User Safety Notice

SCBA Cylinder Quick Connect Adapter

April 21, 2016

12.3 Installing Quick Connect Adapter to Cylinder

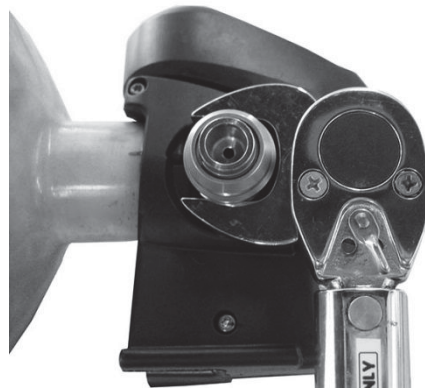
Please note that MSA recently changed the minimum torque requirement in the operating manual from 14 ft-lbs to 13 ft-lbs; however, the maximum allowable torque has remained at 15 ft-lbs since the launch of the quick connect adapter accessory. Also since launch, MSA has made available a torque wrench kit (p/n 10164604 and Crowsfoot adapter (p/n 10164582), as shown in the photo below, to allow for proper installation of the cylinder quick connect adapter. The Crowsfoot and torque wrench must be at a right angle to produce an accurate torque.

1. Use only a fully charged cylinder and inspect the external threads of the cylinder valve to ensure they are not damaged and free of dirt and debris.
 - The bore of the cylinder valve must be undamaged and free from dirt and debris.
 - If the cylinder valve is damaged, remove from service and return it to a MSA trained or certified repair technician.
2. Inspect the internal threads and nipple of the male adapter to ensure it is not damaged and free of dirt and debris.
 - Ensure that the O-ring is installed on the nipple and free of dirt and debris.
3. Thread the adapter onto the cylinder valve.
 - Securely hold the cylinder assembly and tighten the male adapter to the valve to a torque of 13 - 15 ft-lbs (18 - 20 Nm) using the torque wrench.
